To: T10 Technical Committee
From: Bob Sheffield(robert.l.sheffield@intel.com)
Date: 29 August 2006
Subject: 06-378r1: SAT - Miscellaneous changes

Suggested changes

Figure 4 — Example of a SATL between a SCSI application client and an ATA or ATAPI device

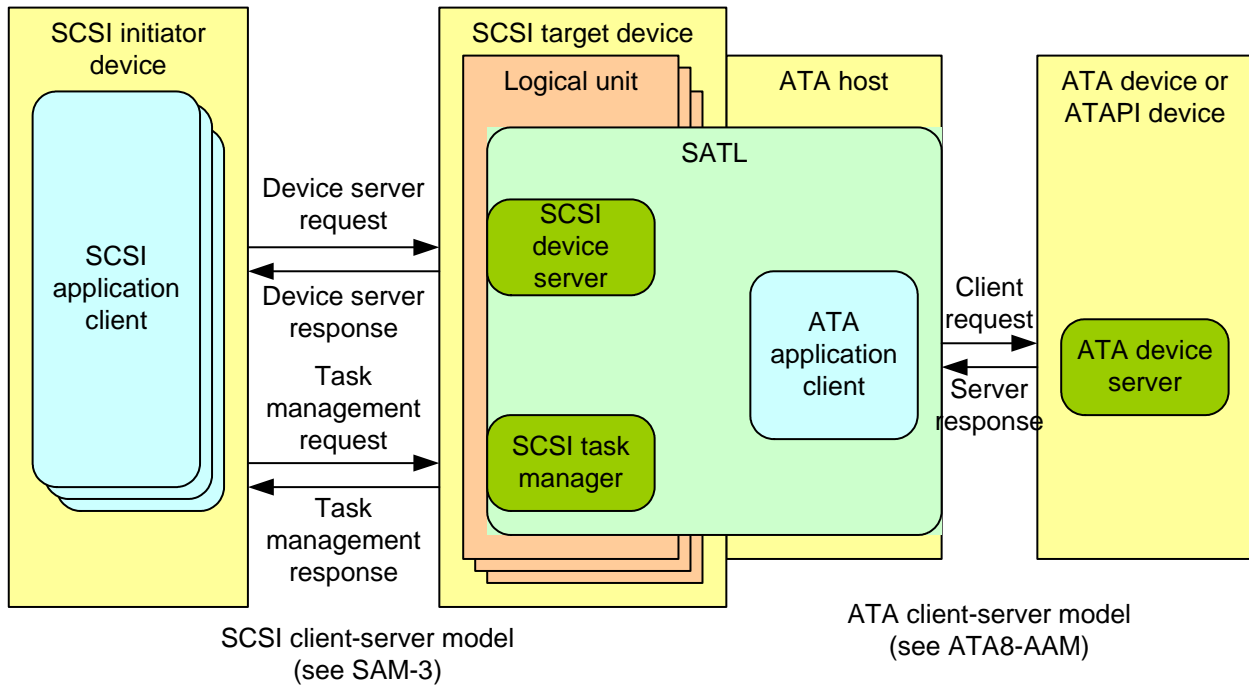
Editor's Note 3: Replaced figure-4. This is more consistent with figures in SAM-3 and ATA8-AAM. Credit goes to Rob Elliott for creating this diagram.
